Item ID: D412-664-203TRN

Item Name: Crosstube Turning Detail

DART AEROSPACE LTD	Work Order: 10717Y
Description: Crosstube Assembly (412 High Aft)	Part Number: D412-664-243
Inspection Dwg: D412-664-243 Rev: E	Page 1 of 2

DRAWING NO. D412-664-243	TITLE CROSSTUBE ASSEMBLY (412 HI AFT)	REV. E	DART AEROSPACE LTD ENGINEERING ORDER	D.E.O. NO. D412-664-243-E-4	SHEET NO. SHEET 1 OF 3	SCALE NTS
DRAWN <i>92</i>	CHECKED <i>h</i>	MFG. APPR. <i>A</i>	APPROVED <i>MP</i>	DE APPR. <i>h</i>		
DATE 12.08.21	DATE 12.08.30	DATE 12.08.30	DATE 12/8/30	DATE 12.08.30

**D412-664-243
ASSEMBLY DETAIL**

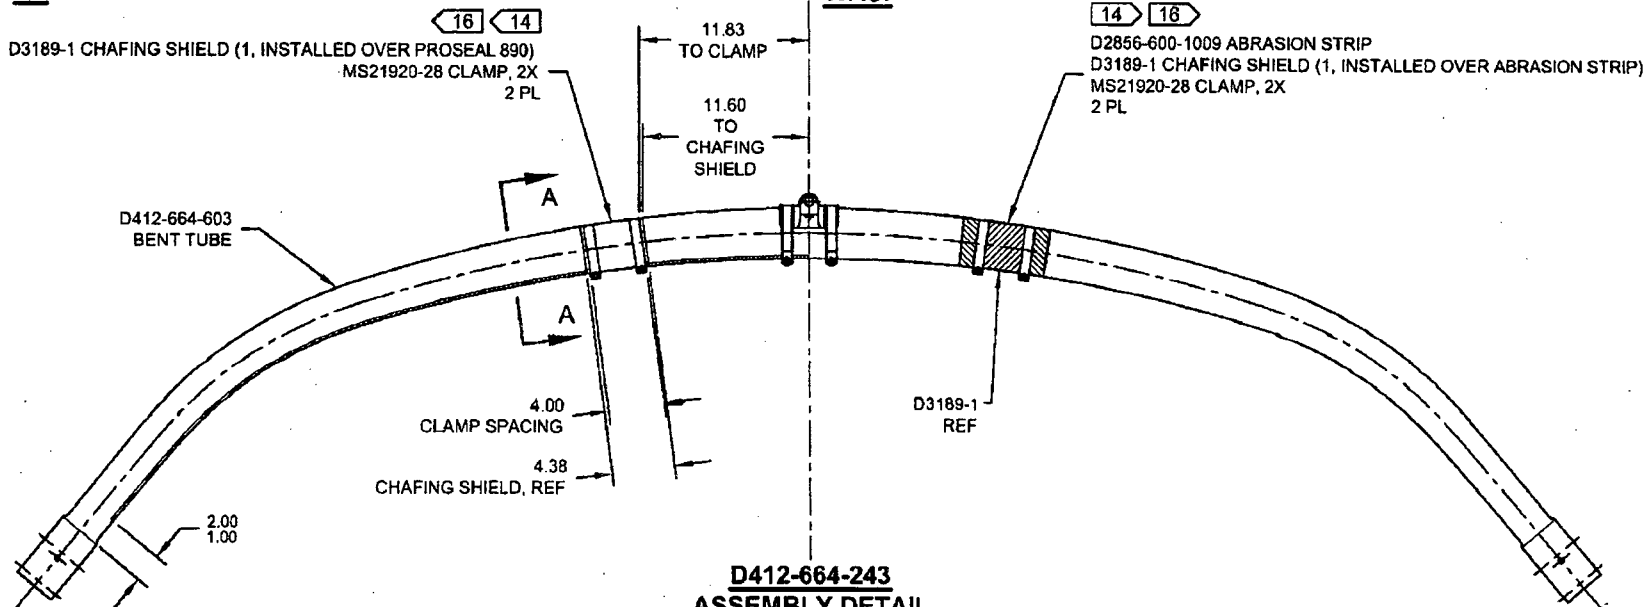
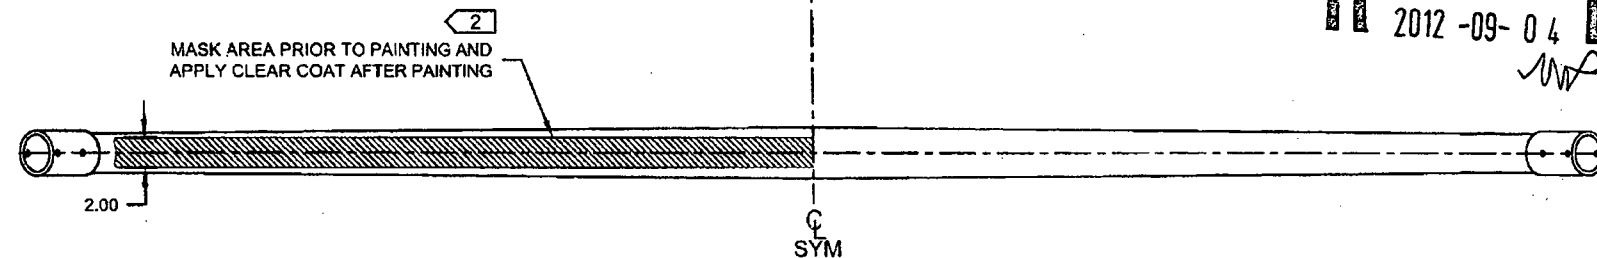
REMOVED ABRASION STRIP IN FAVOR OF A THIN LAYER OF PROSEAL 890. UPDATE INSTALLATION OF CHAFING SHIELDS AND REDUCE TORQUE TO 40-50 IN-LBS. THIS ENGINEERING ORDER SUPERCEDES DEO D412-664-243-E-1.

IS:

D3189-1 CHAFING SHIELD (1, INSTALLED OVER PROSEAL 890)
MS21920-28 CLAMP, 2X
2 PL

WAS:

D2856-600-1009 ABRASION STRIP
D3189-1 CHAFING SHIELD (1, INSTALLED OVER ABRASION STRIP)
MS21920-28 CLAMP, 2X
2 PL

SECTION A-A
CHAFING SHIELD DETAIL
VIEW ROTATED, NOT TO SCALE

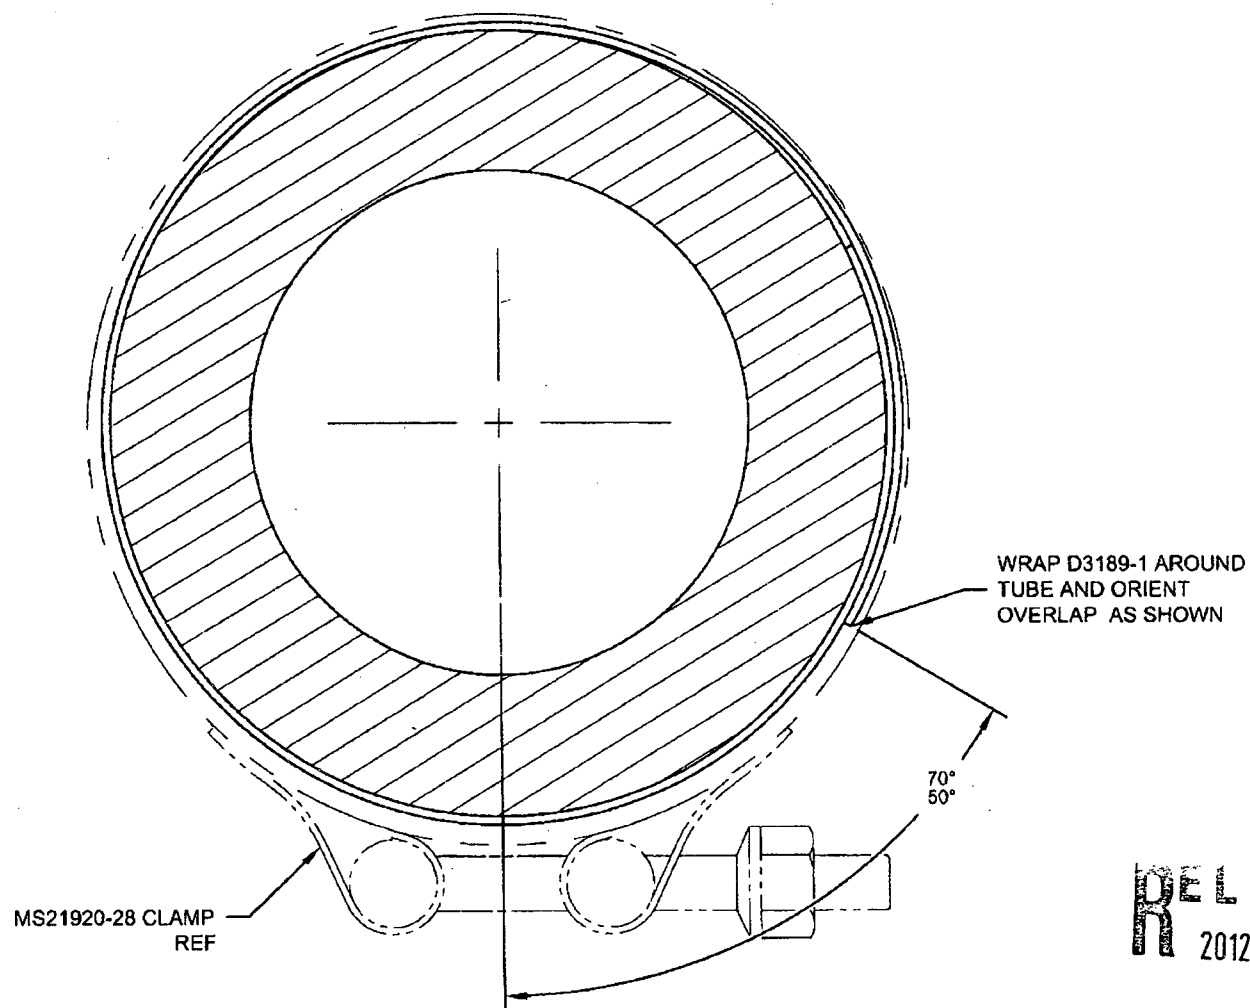
NOTES 2, 14, AND 16 ON SHEET 1 ARE AMENDED AS FOLLOWS:

- 2) FINISH: CHEMICAL CONVERSION COAT PER DART QSI 005 4.1
PRIME INSIDE AND OUTSIDE PER DART QSI 005 4.2
MASK UNDERSIDE OF CROSSTUBE AS SHOWN (HATCHED AREA)
PAINT OUTSIDE PER DART QSI 005 4.2
AFTER PAINTING, APPLY CLEAR COAT ON HATCHED AREA
- 14) APPLY A THIN COAT OF PROSEAL 890 ON INSIDE CONCAVE SURFACE OF D3189-1 CHAFING SHIELD AND LET CURE PER MANUFACTURER'S INSTRUCTIONS. INSTALL PROSEALED D3189-1 CHAFING SHIELD ONTO CROSSTUBE BY APPLYING A THIN COAT OF PROSEAL 890 ONTO CROSSTUBE. BE SURE TO ELIMINATE ANY AIR GAPS.
- 16) TORQUE CLAMPS ON D2896-1 SUPPORT 80 TO 100 IN-LB. **TORQUE CLAMPS ON D3189-1 CHAFING SHIELD 40 TO 50 IN-LB.** ENSURE AT LEAST 1.5 THREADS SHOWING IN SAFETY AND THAT NUT HAS NOT BOTTOMED-OUT AFTER TORQUING.
